Enclosure A
L-21-002

EVALUATION OF PROPOSED CHANGE

Subject: Request to Revise the Methodology Used for Flooding Hazard Analysis and Revise the Flood Hazard Protection Scheme

Figure 2-1: Present-Day Site Layout

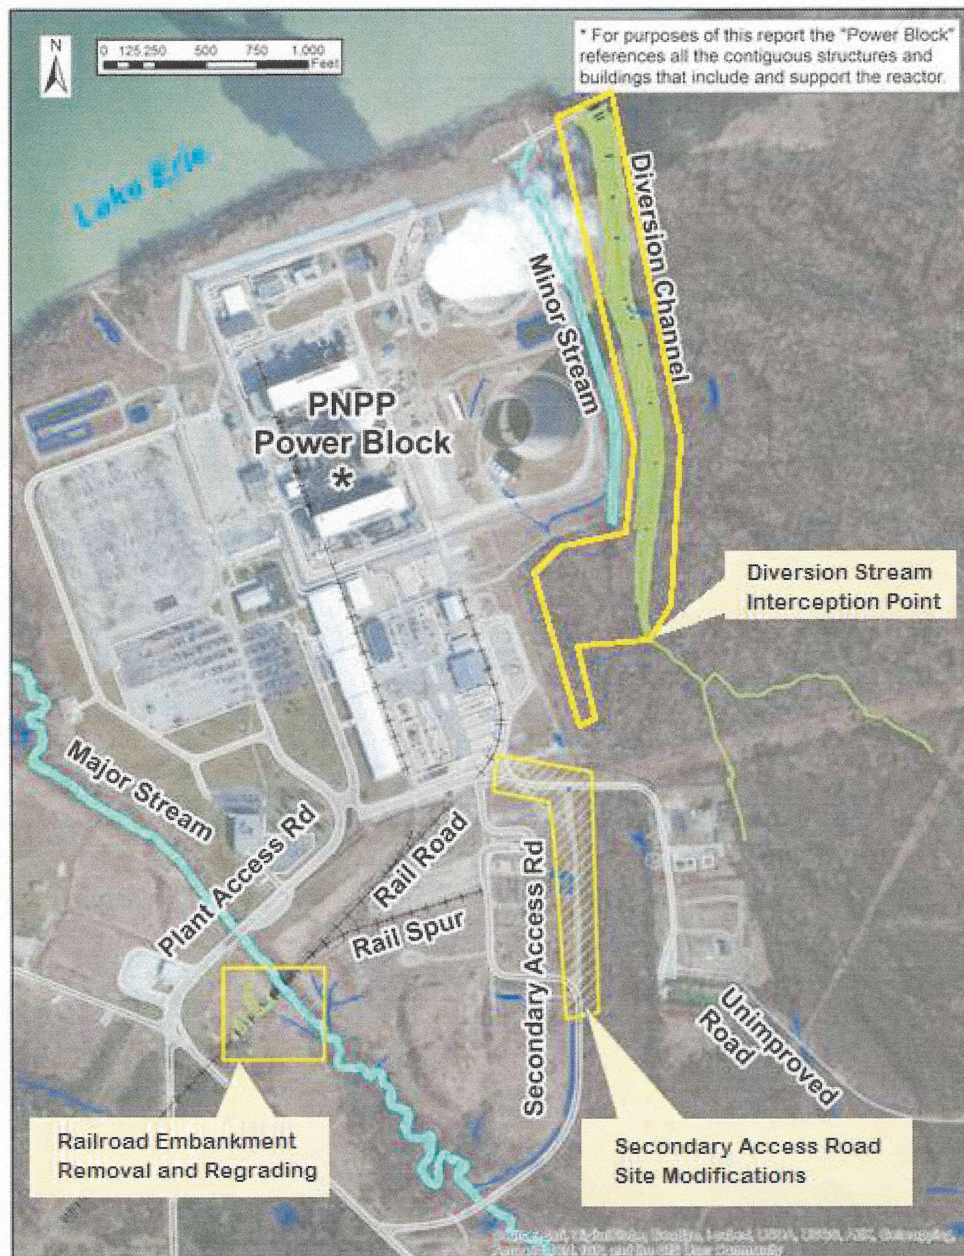
Additional modifications to the plant site (shown on Figure 2-1 above) were made as a result of the re-evaluated external flooding hazards in response to the 10 CFR 50.54(f)

letter. Modifications were made to the Major Stream and Minor Stream, establishing the Diversion Stream to reroute the south reaches of the Minor Stream.

With respect to the Major Stream, a portion of the existing rail line embankment to the southwest of the rail line bridge crossing the Major Stream was removed. Removal of the embankment allows greater conveyance of flow in the southern overbanks of the Major Stream, preventing flow from overtopping the rail line. Furthermore, the secondary (contractor) access road was raised to prevent any remaining backwater from overtopping the road. This modification resulted in the concentration of Major Stream runoff to be carried downstream to Lake Erie, rather than contributing to runoff to other areas of the site.

With respect to the Minor Stream, the stream no longer functions as a stream or river due to the installation of a new Diversion Stream, which intercepts the previous Minor Stream and its watershed and diverts runoff flow directly to Lake Erie. A portion of the originally engineered Minor Stream remains located between the plant area and the Diversion Stream. This section of the stream no longer functions as a traditional stream. The Remnant Minor Stream, as it is now referred to, is a drainage swale located entirely within the LIP computational domain. Also, an engineered earthen embankment (termed the Diversion Stream berm) was installed to separate the LIP domain from the Diversion Stream and the original Minor Stream watershed.

Figure 2-2: LIP Domain

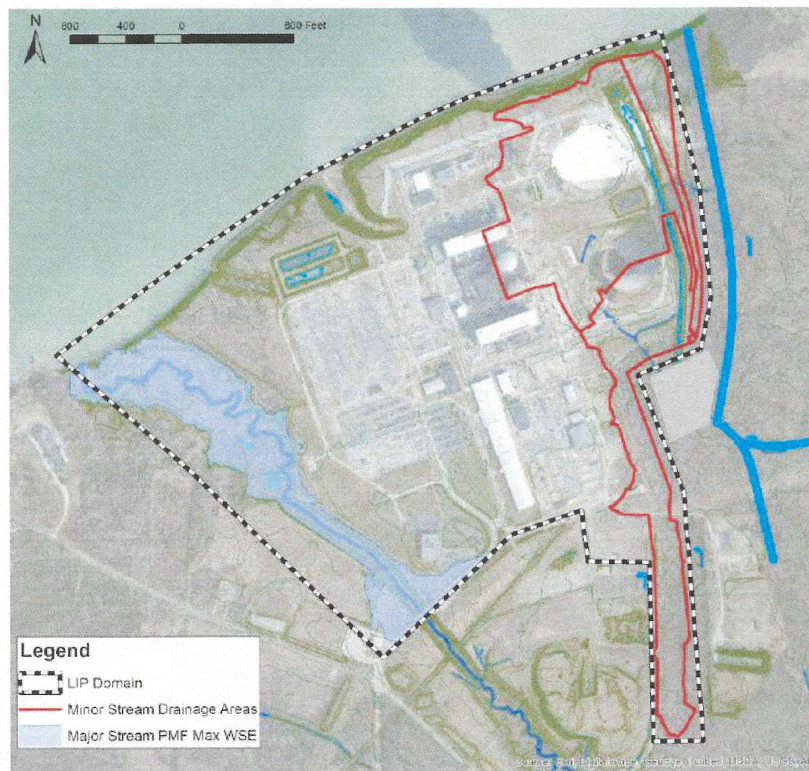
The LIP domain is shown in Figure 2-2 below. The PNPP USAR presents the probable maximum precipitation (PMP) event as being a 48-hour rainfall event with a cumulative rainfall of 33.9 inches over this period with the peak hourly intensity of 13.1 inches per hour. For LIP considerations, a front-loaded storm temporal distribution is postulated, using a 6-hour subset of the 48-hour PMP event. The rain event used for LIP considerations is based on the guidance of Hydrometeorological Report (HMR) 33 with hourly distribution taken from the Bureau of Reclamation's Design of Small Dams (Second Edition).

As a result of the site grading, overland flow of storm water will begin once ponding has reached EL 620 ft 4 inches. Assuming the worst case (that is, complete blockage of the site storm drain system and using peak discharge from the most intense hour of the PMP), the resulting increase in surface elevation of water flowing over the surrounding roads and railroads (acting as weirs) on site would not exceed one inch. Therefore, the ponding level of EL 620 ft 5 inches provides a one-inch margin over the nominal floor levels at plant grade of EL 620 ft 6 inches.
